## Product Change Notification - SYST-05UUSH874

ERRATA - PIC18(L)F26/45/46K40 Family Silicon Errata and Data Sheet Clarification

## PIC18(L)F26/45/46K40 Family Silicon Errata and Data Sheet Clarification

**Figure 1. 28-pin SPDIP, SSOP, SOIC**

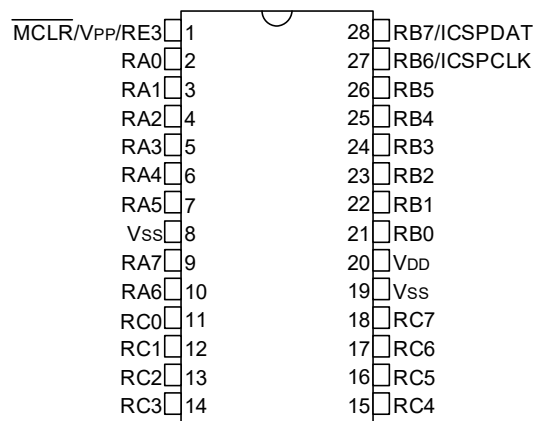
The correct marking for pin 26 on the 28-pin SPDIP/SSOP/SOIC package is **RB5**.

**Figure 3. 40-pin PDIP**

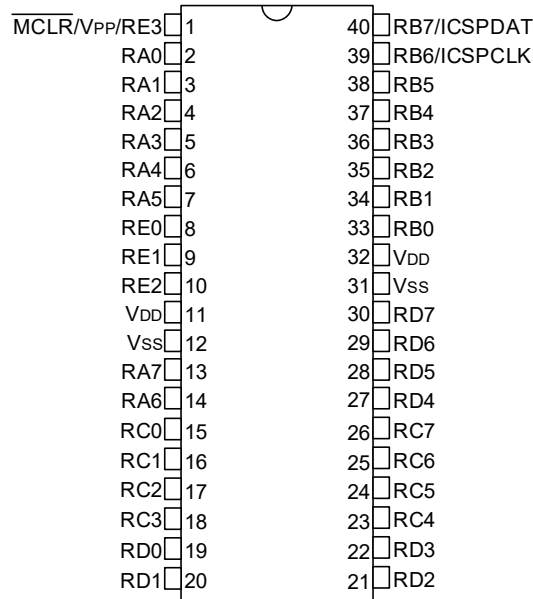
The correct marking for pin 38 on the 40-pin SPDIP package is **RB5**.

**Figure 38-10: ADC Conversion Timing (ADC Clock F<sub>OSC</sub>-Based)**

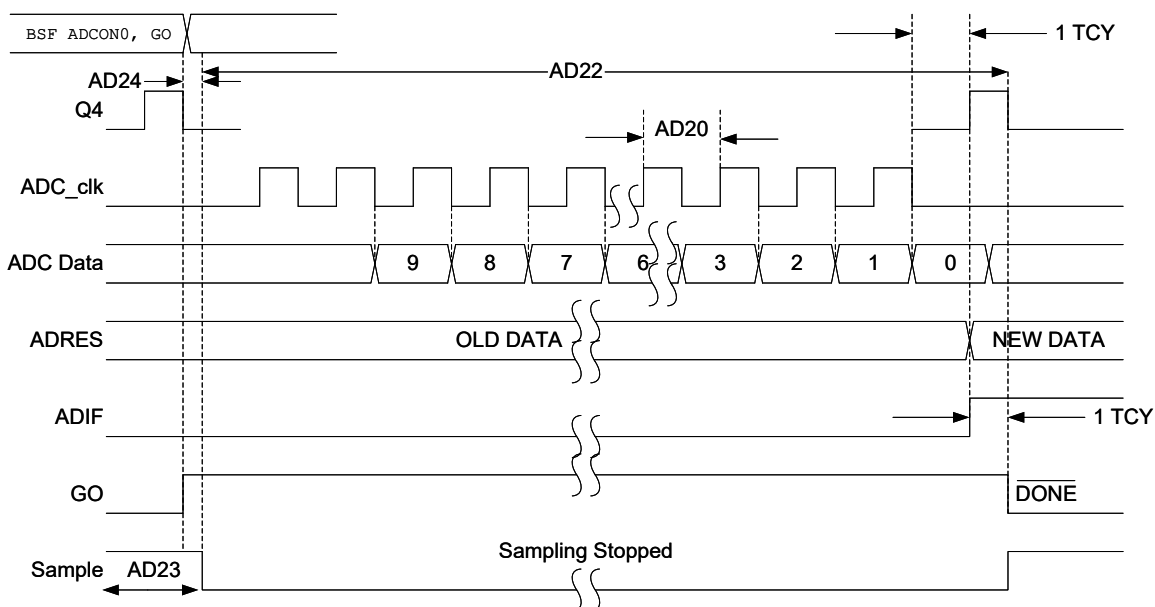
Refer to the images below for corrections of Figure 38-10 and Figure 38-11. Previously, the parameter numbers were incorrect.
